New High School in Bungendore

State Significant
Development Application
(SSD-14394209)

Architectural + Landscape Design Report Addendum

Rev B
September 2022
Project No. 200096

11 Integration of Outdoor Learning Areas

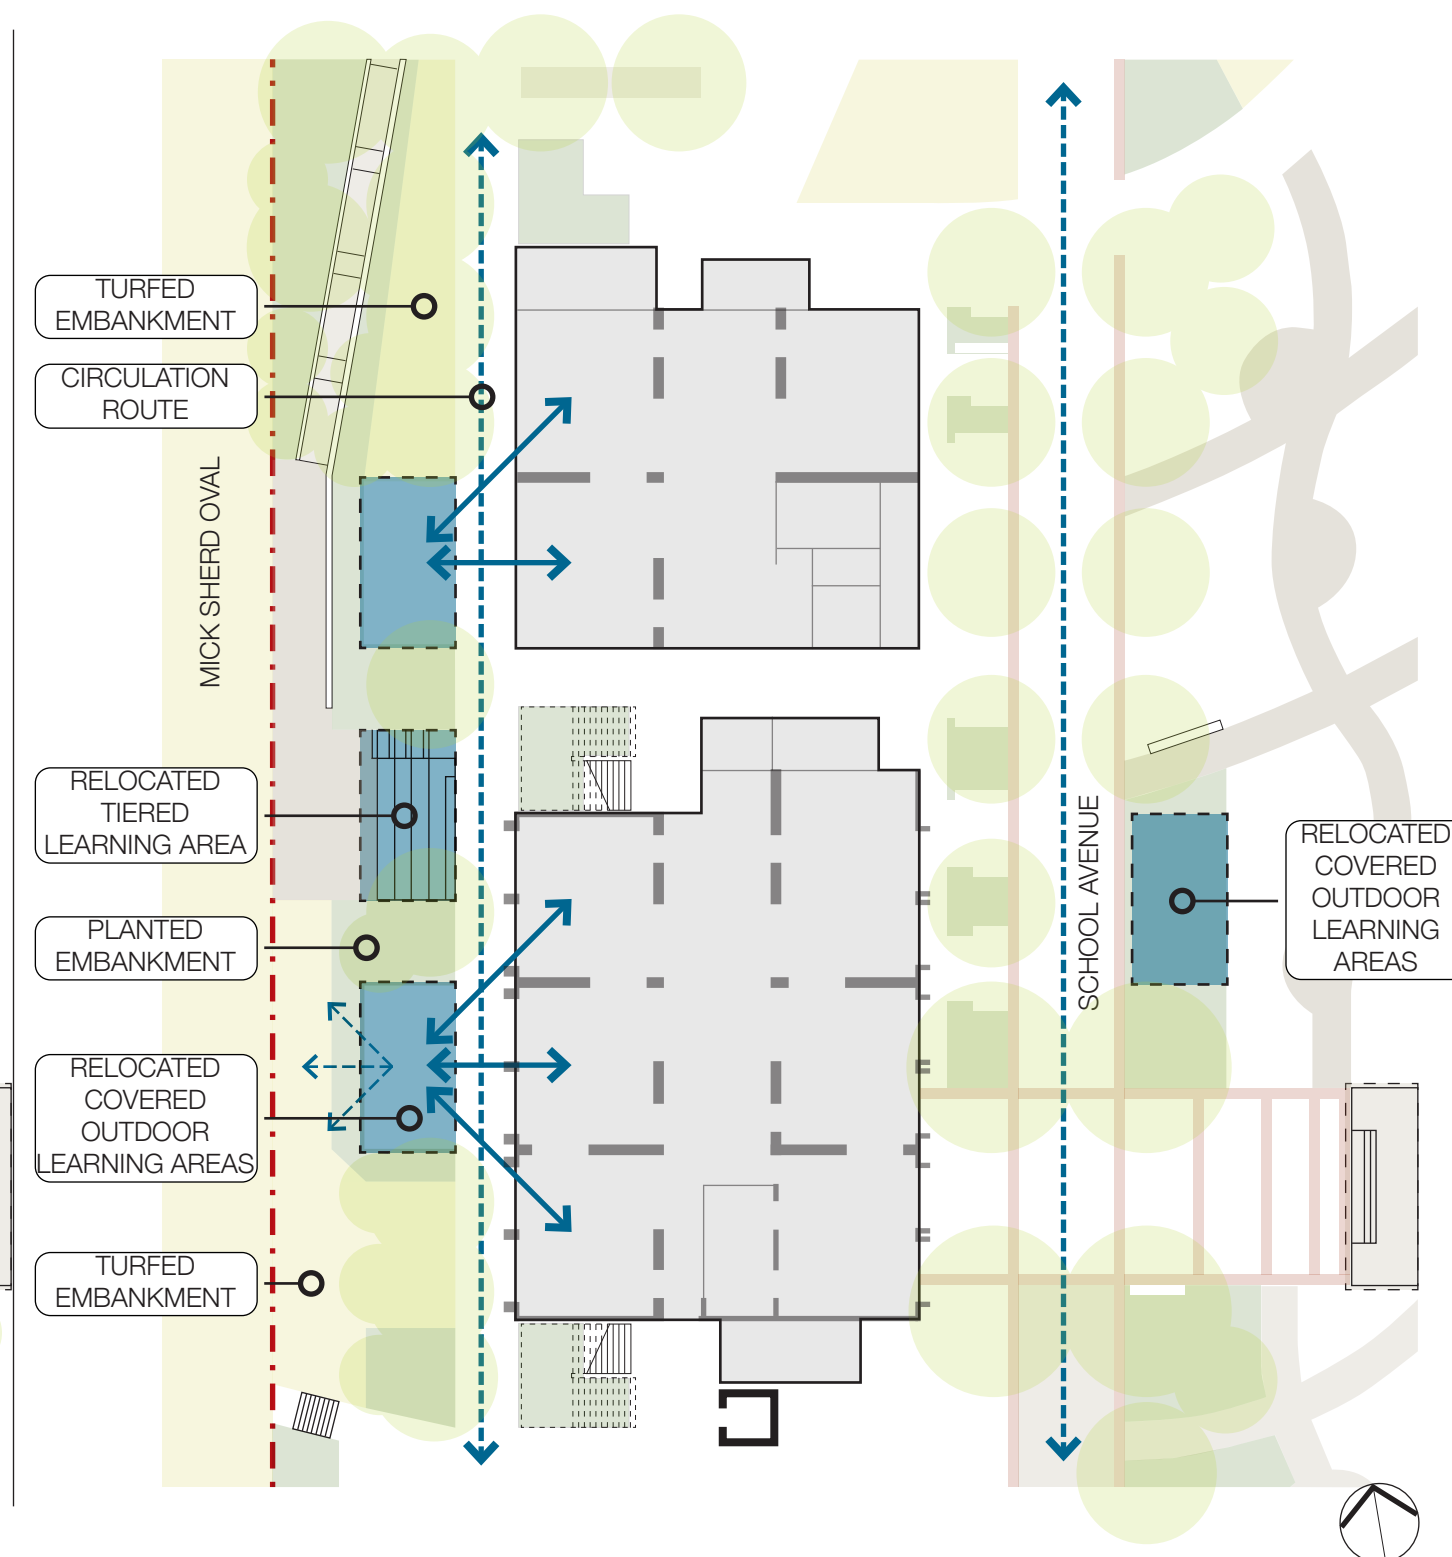
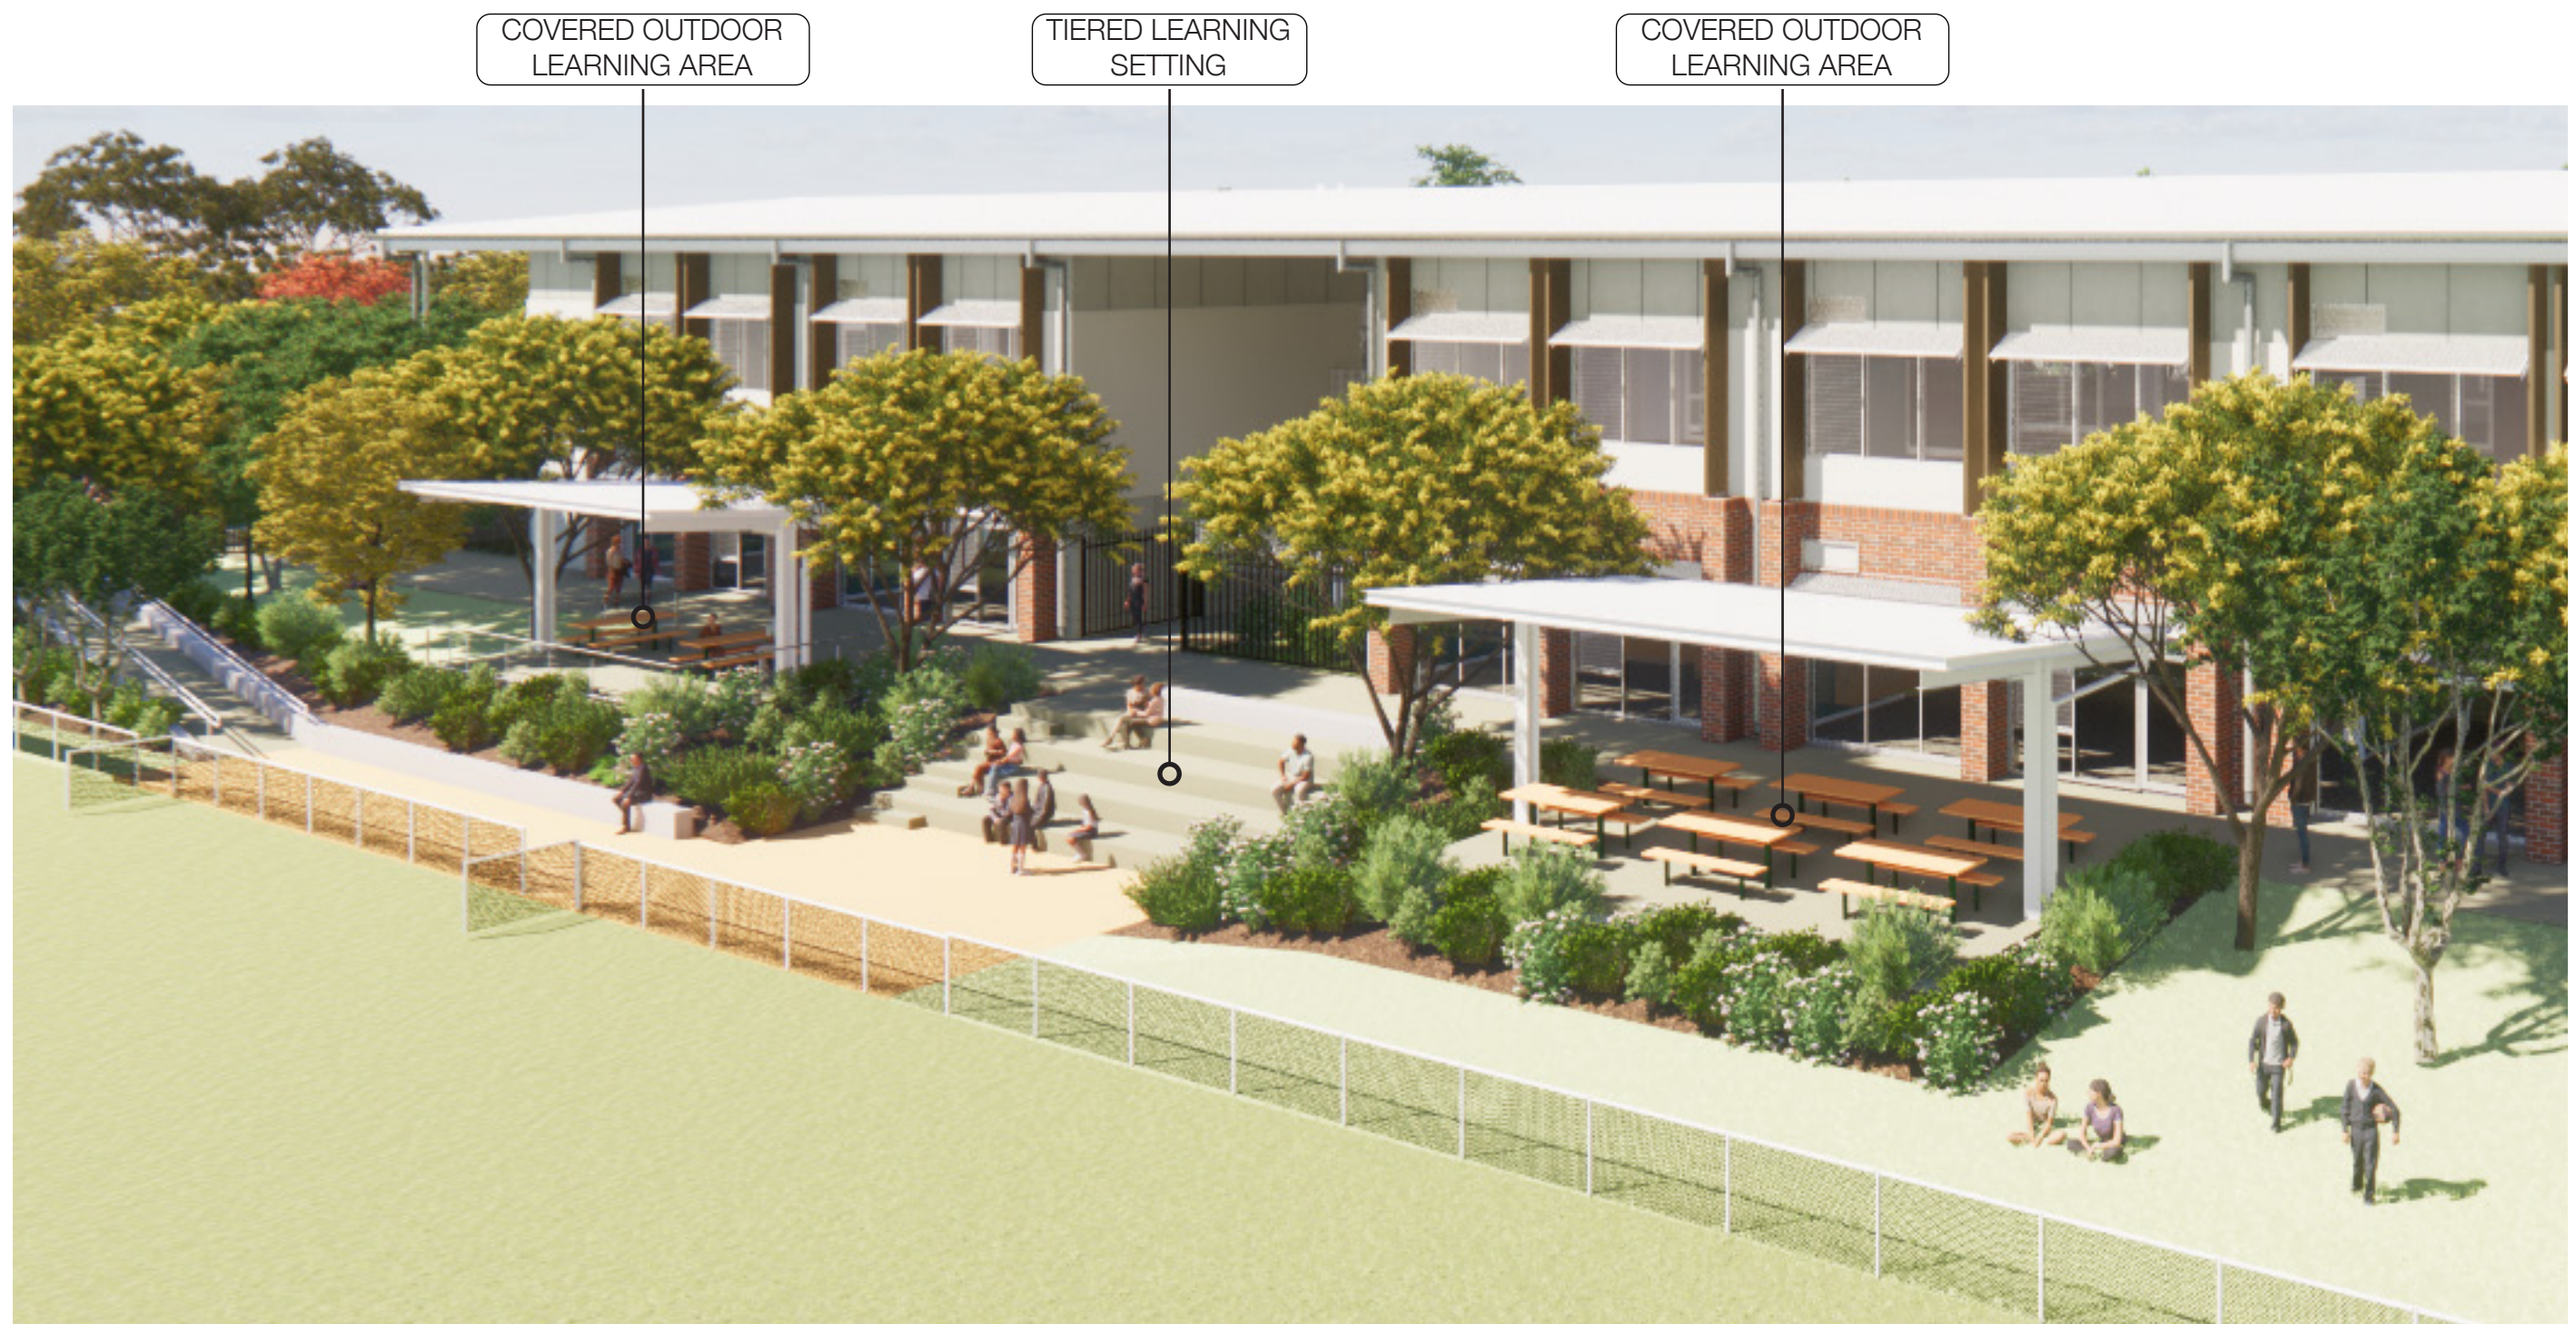
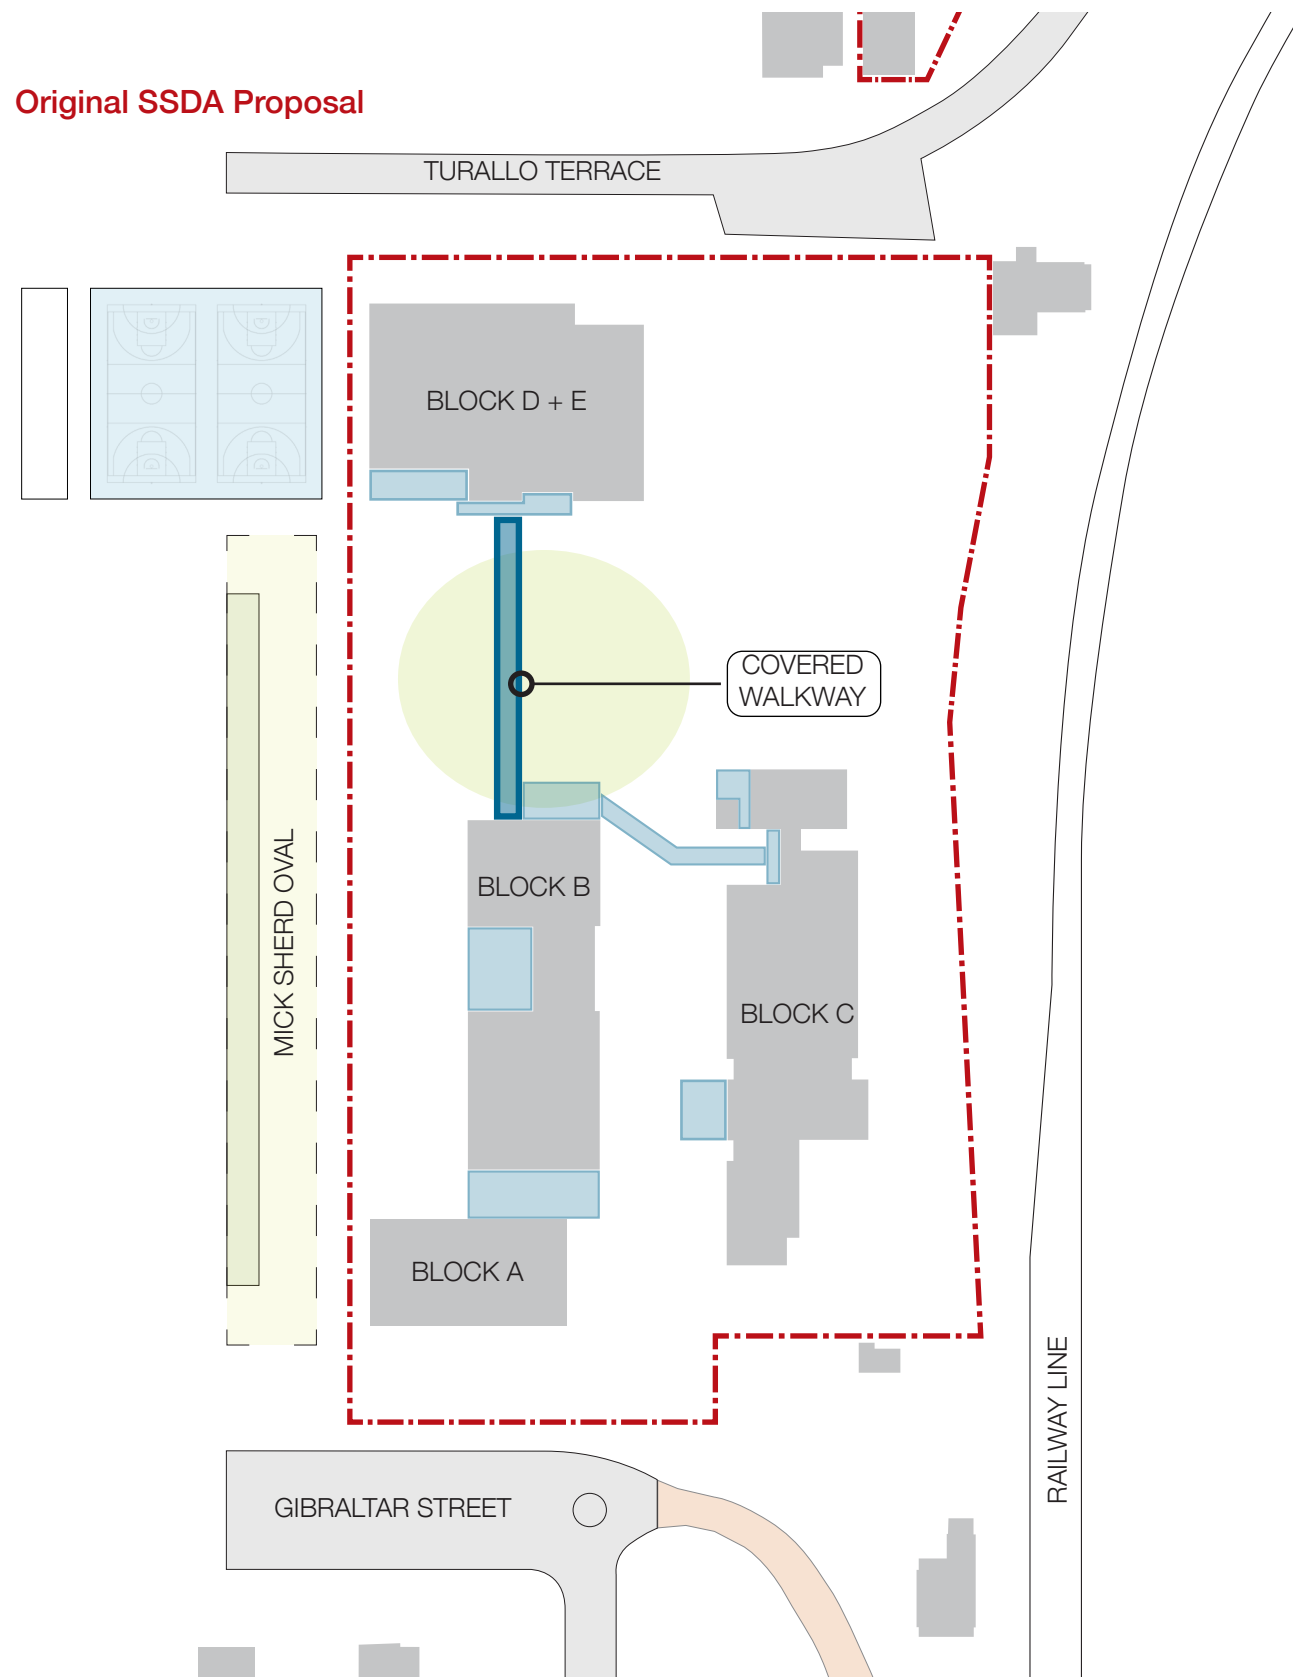
The primary outdoor learning areas have been relocated and redesigned to be more integral within the landscape. Outdoor learning areas have been generally relocated from the central covered area between the two Block B wings, to the west of the General Learning Spaces to provide improved physical and visual connections from the classrooms, as well as providing improved spectating opportunities to the oval. Smaller covered areas have been consolidated to make them larger, more usable spaces.

The western learning areas consist of two covered learning areas and the tiered learning setting, nestled between planted embankments. The slightly raised covered learning areas which sit level with the classrooms, and the tiered learning area utilise the natural level change to provide high quality views over the oval. A third covered learning area has been relocated to the east of Block B along the School Avenue. The design of the covered learning areas have been simplified to express a lightweight cantilever structure.
